NO.	DATE	REVISION
1	02/11	ADDENDUM NO. 1

WPCP REHABILITATION PROJECT

DEMOLITION

EXISTING HEADWORKS AND INFLUENT PUMP STATION LOWER PLAN AND SECTION

LANDSCAPE
 IRRIGATION PLAN
 AREA 4

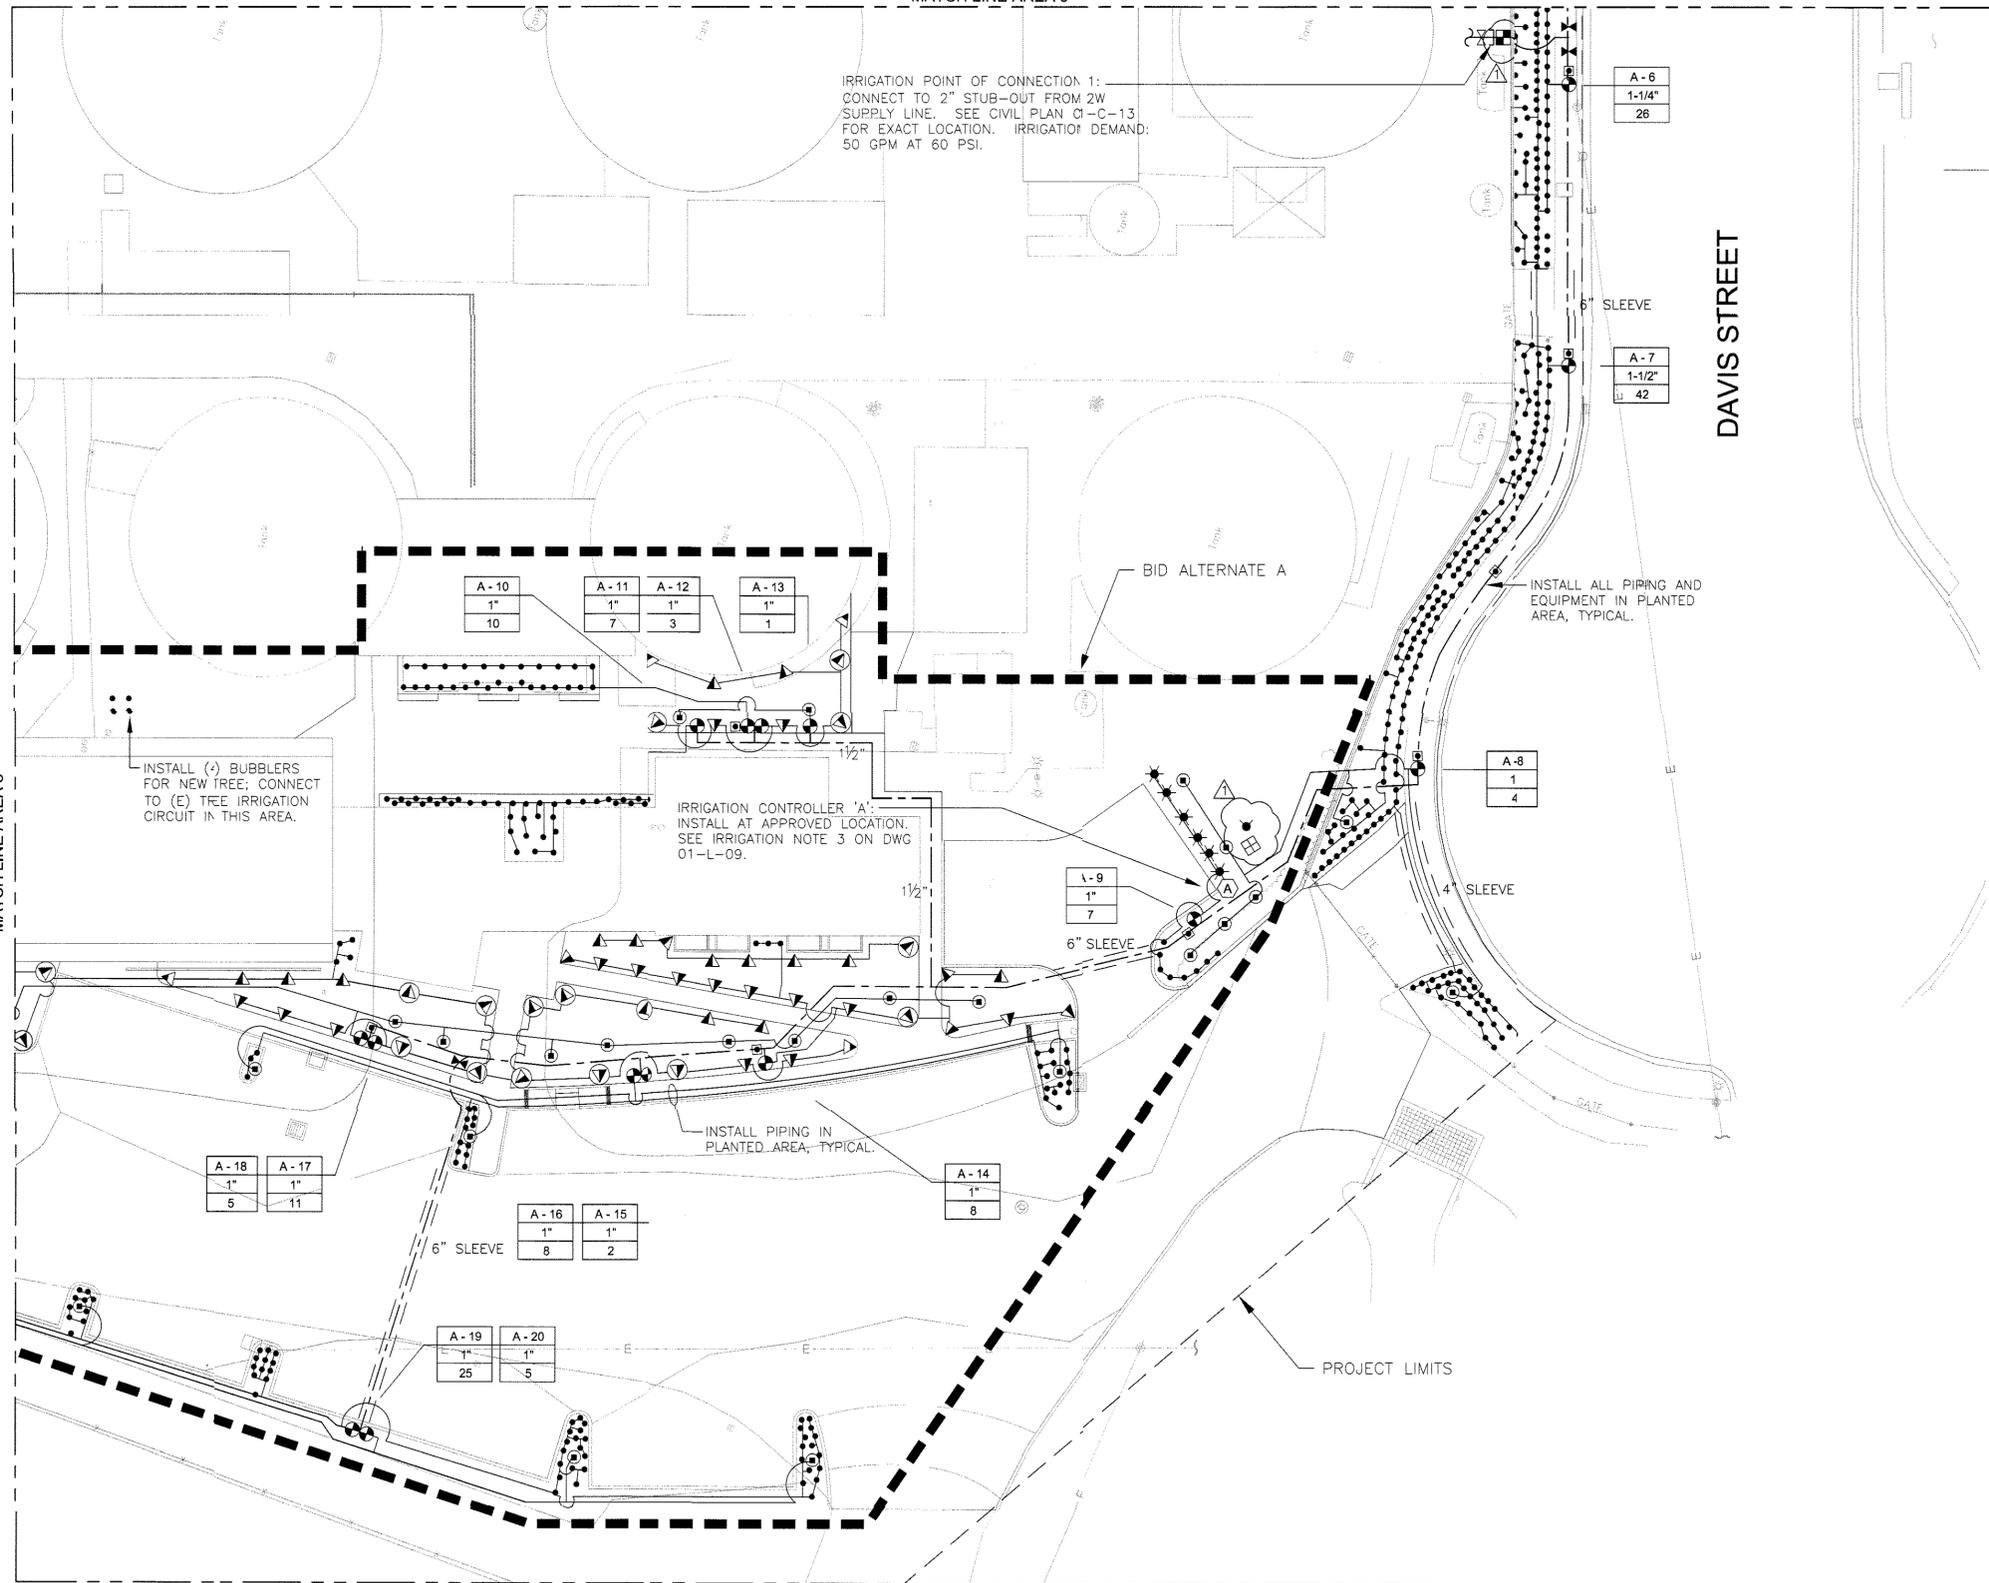
IRRIGATION POINT OF CONNECTION 1:
CONNECT TO 2" STUB-OUT FROM 2W
SUPPLY LINE. SEE CIVIL PLAN CI-C-13
FOR EXACT LOCATION. IRRIGATION DEMAND:
50 GPM AT 60 PSI.

INSTALL (-) BUBBLERS FOR NEW TREE; CONNECT TO (E) TREE IRRIGATION CIRCUIT IN THIS AREA.

IRRIGATION CONTROLLER 'A':
INSTALL AT APPROVED LOCATION.
SEE IRRIGATION NOTE 3 ON DWG
01-L-09.

INSTALL PIPING IN
PLANTED AREA-TYPICAL.

INSTALL ALL PIPING AND
EQUIPMENT IN PLANTED
AREA, TYPICAL.

DOMES PLAN - DIGESTER NO. 4
 SCALE: 1/16" = 1'-0"
 FILE: D:\#4 Plan.Tif

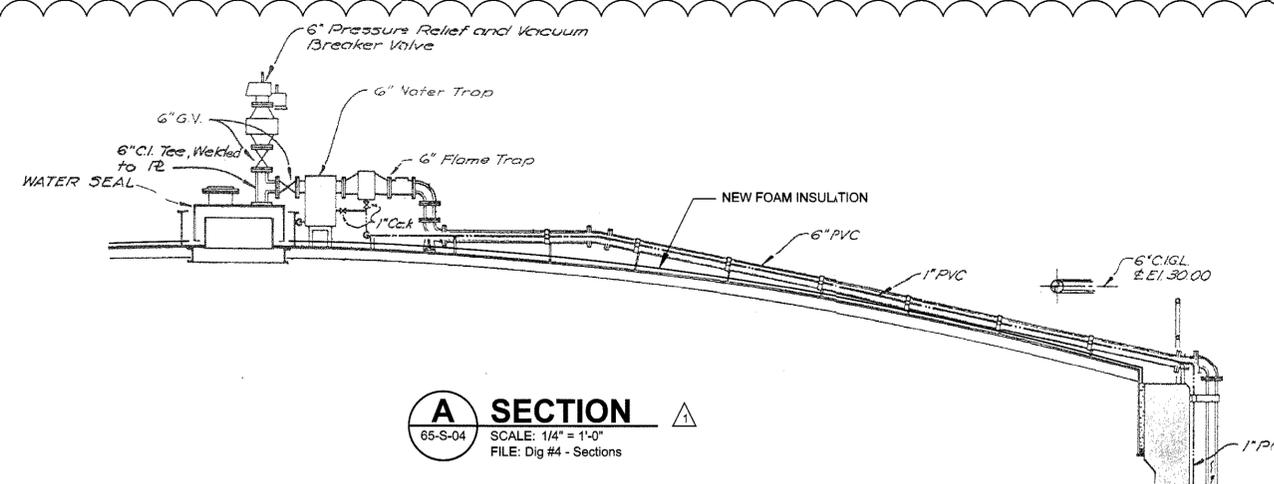
- NOTES:**
- REMOVE EXISTING INSULATION OVER ENTIRE STEEL DIGESTER DOME EXTERIOR SURFACE. PROTECT EXISTING PIPING AND APPURTENANCES.
 - REMOVE WOOD WALKING SURFACES. PROTECT EXISTING STRUT SUPPORTS.

- COAT STEEL DIGESTER DOME COVER EXTERIOR SURFACES WITH HIGH SOLIDS EPOXY AND POLYURETHANE SYSTEM PER SECTION 09960 BEFORE INSULATING.
 - PROVIDE SPRAY-IN-PLACE POLYURETHANE FOAM INSULATION FOR ENTIRE COVER PER SECTION 07570.

- INSTALL 1" DEEP FRP GRATING ON EXISTING STRUT SUPPORTS. SECURE W/ TYP 316 SST HOLD DOWN CLIPS. CONFORM TO COVER CURVATURE.
 - COAT EXTERIOR OF VIEWPORTS WITH HIGH SOLIDS EPOXY AND POLYURETHANE SYSTEM PER SECTION 09960 (TYP OF 4).

- COAT EXTERIOR OF SAMPLING TUBE WITH HIGH SOLIDS EPOXY AND POLYURETHANE SYSTEM PER SECTION 09960 (TYP OF 4).
 - COAT EXTERIOR OF MANWAY WITH HIGH SOLIDS EPOXY AND POLYURETHANE SYSTEM PER SECTION 09960 (TYP OF 2).

- COAT EXTERIOR OF INLET BOX AND INLET PIPING AND SUPPORTS FROM INLET BOX TO ROOF OF MIXING AND HEATING BUILDING WITH HIGH SOLIDS EPOXY AND POLYURETHANE SYSTEM PER SECTION 09960.

- COAT G/S PIPING AND SUPPORTS AND INTERIOR AND EXTERIOR SURFACES OF WATER SEAL STRUCTURE FROM WATER SEAL STRUCTURE TO GROUND SURFACE WITH HIGH SOLIDS EPOXY AND POLYURETHANE SYSTEM PER SECTION 09960.

- COAT STEEL LIGHTING STANCHION SUPPORTS WITH HIGH SOLIDS EPOXY AND POLYURETHANE SYSTEM PER SECTION 09960 (TYP-3 LOCATIONS).
